AMENDMENTS TO THE DRAWINGS

REMARKS

FIG. 1
PRIOR ART

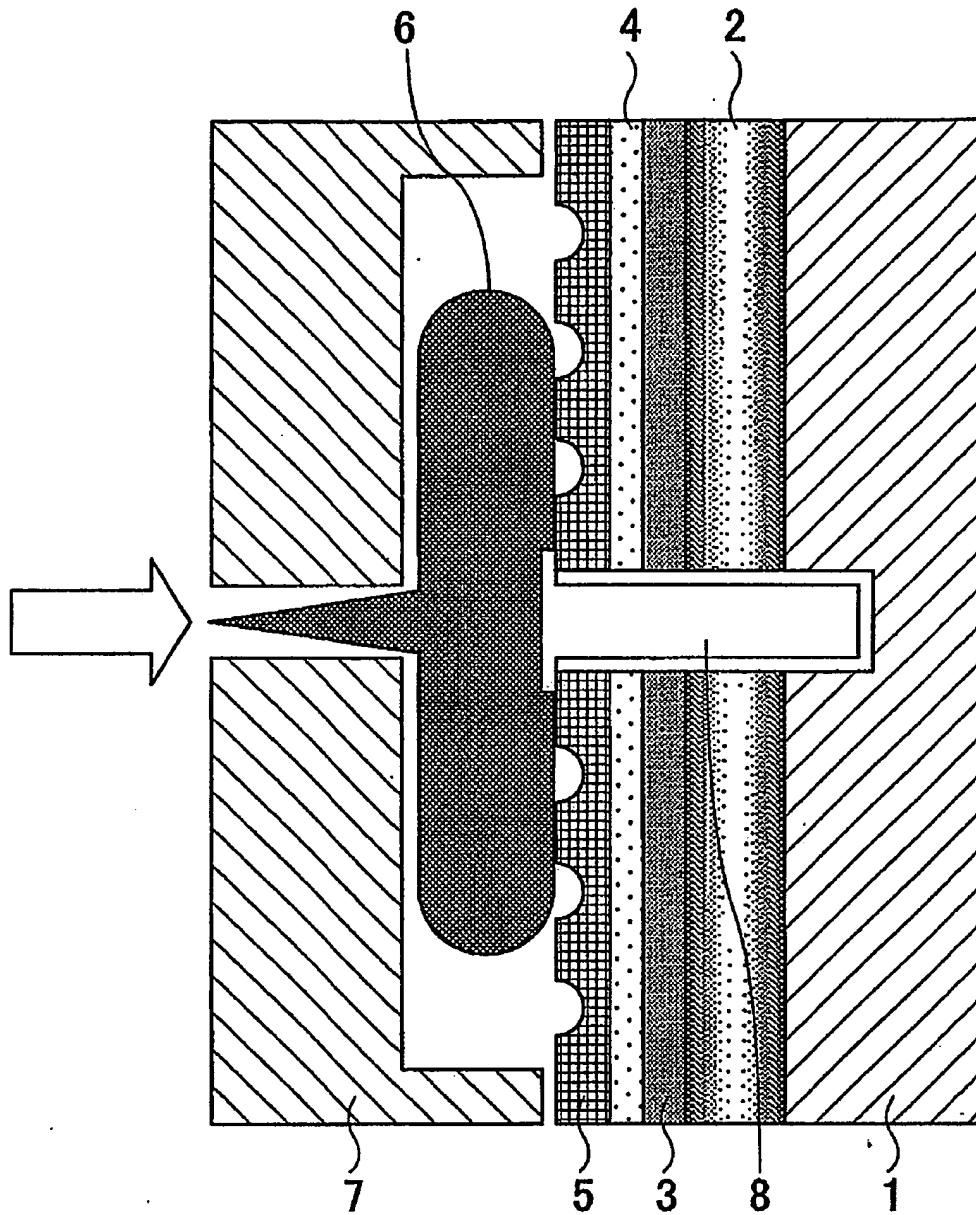
Figures 1, 2, 6 and 8 are objected to. Figures 1, 2, 6 and 8 have been amended to be designated as "Prior Art." As such, Applicants respectfully submit that the figures are in condition for allowance and request that the objection be withdrawn.
